# UNITED STATES PATENT AND TRADEMARK OFFICE

APPLICATION NO.	FILING DATE	FIRST NAMED INVENTOR	ATTORNEY DOCKET NO.	CONFIRMATION NO.
10/810,273	03/26/2004	Takateru Satoh	02157/0201088-US0	8531
7278	7590	11/14/2006	EXAMINER	
DARBY & DARBY P.C. P. O. BOX 5257 NEW YORK, NY 10150-5257			KAYRISH, MATTHEW	
			ART UNIT	PAPER NUMBER
			2627

<b>Office Action Summary</b>	<b>Application No.</b>	<b>Applicant(s)</b>	
	10/810,273	SATO ET AL.	
	<b>Examiner</b>	<b>Art Unit</b>	
	Matthew G. Kayrish	2627

## **DETAILED ACTION**

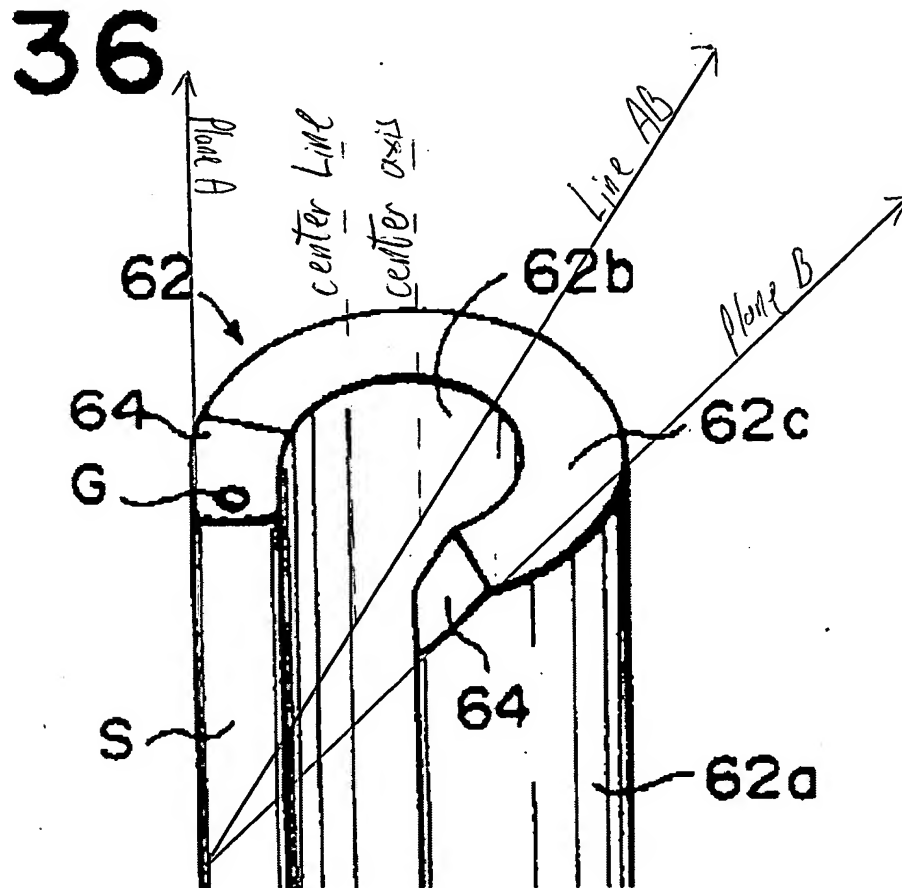
Chamfered portions (figure 36, item 64) are provided at edge portions of the opening of said clamp member (figure 36, (column 20, lines 37-42)), said chamfered portions having a slope orthogonal to a plane passing between a center axis of the

cylindrical body and a center line of the opening (see figure 36 below, any plane that is orthogonal to line AB will be orthogonal to the slopes of both chamfered portions and will pass between the center axis and a center line of the slit).
